#### **Rezoning Application:** PD 21-0969

**Development Services Department**

#### **1.0 APPLICATION SUMMARY**

# 8.0 PROPOSED SITE PLAN (FULL) 1 of 2

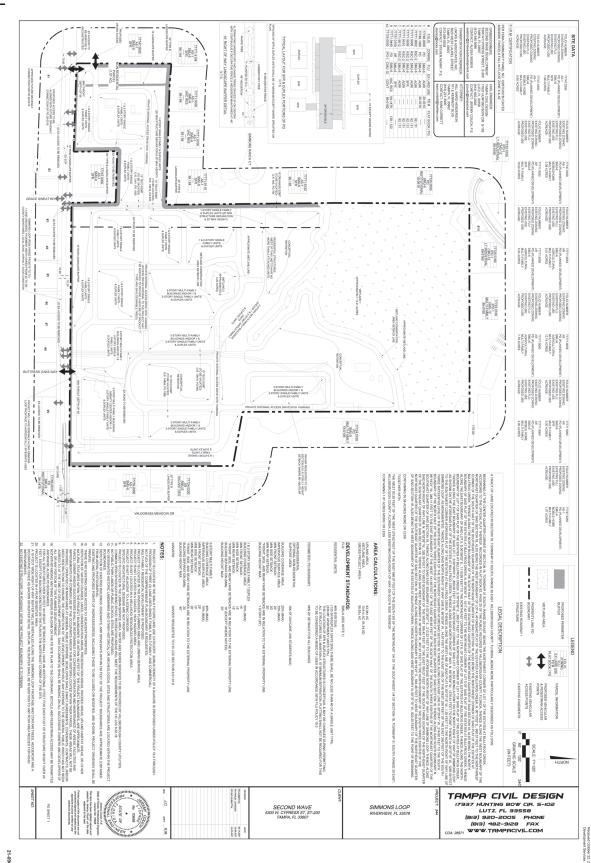
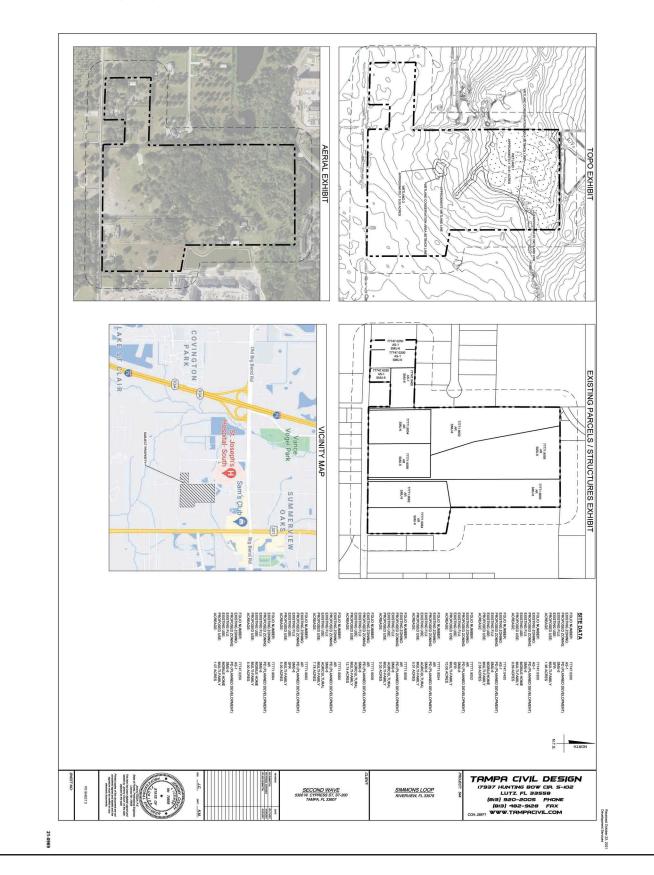
Prior to PD Site Plan Certification, the applicant shall revise the PD General Site Plan:

- 1. Amend the site data table and remove the word 'Optional" from the Non-residential Support Uses.
- 2. Amend the maximum lot coverage to 40% for the residential component land area.
- 3. Revise the note stating "SIMMONSLOOP (ROW VARIES FROM 70' TO 72') 1 LANE UNDIVIDED", to say "SIMMONSLOOP (ROW VARIES FROM +/- 62' TO 72') 2 LANE UNDIVIDED" and depict/label the points of minimum and maximum right-of-way variance.
- 4. Revise the label stating "PROPOSED CROSS ACCESS" to folio#77747.0000 to say "VEHICULAR AND PEDESTRIAN CROSS ACCESS".
- 5. Amend Note 15 (Cross access will be provided to the west).

PD PLAN

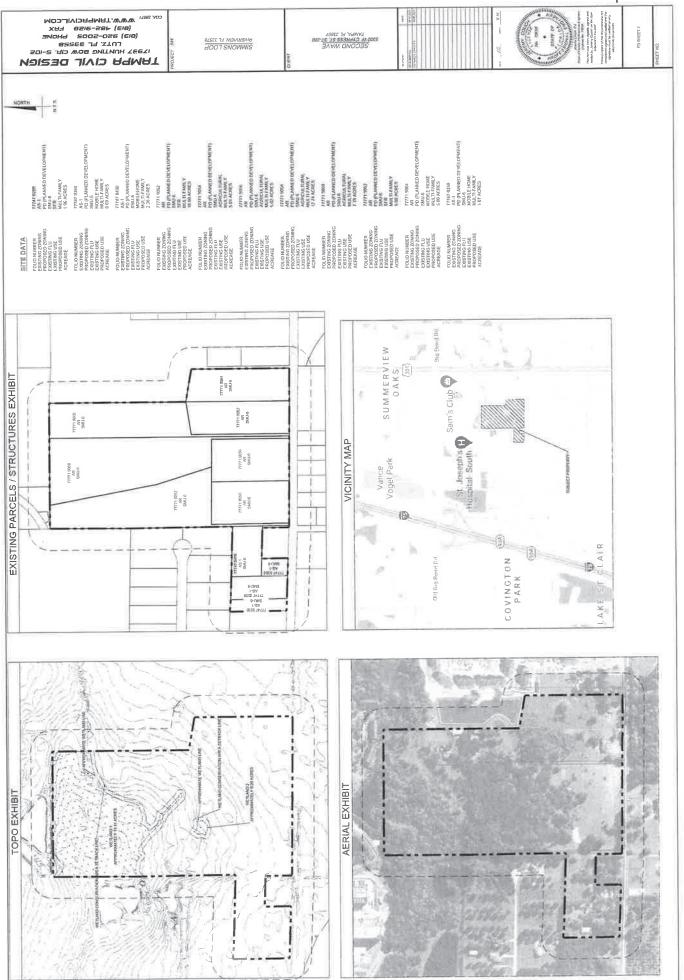
The request is for an Administrative Variance to Section 6.04.07 of the Hillsborough County LDC for the access spacing on Simmons Loop. Based on Section 6.04.07, the access spacing for Simmons Loop is 245 feet and the spacing from the western access to the access to the west is 55 feet. This is graphically shown in Figure 1.

The applicant submitted a Section 6.04.02.B. Administrative Variance Request (dated October 14, 2021) from the Section 6.04.07 LDC requirement, governing minimum spacing for access connections (driveways). The project's western access connection is planned to align with the approved access connection to the south for PD 20-0310 (Simmons Village North), however there is an existing single residential driveway on the north side of Simmons Loop Rd. +/-55 feet to west of the proposed access connection. The LDC a minimum of 245 feet spacing between driveways on Simmons Loop Rd. Based on factors presented in the Administrative Variance Request, the County Engineer found the request approvable on November 3, 2021.
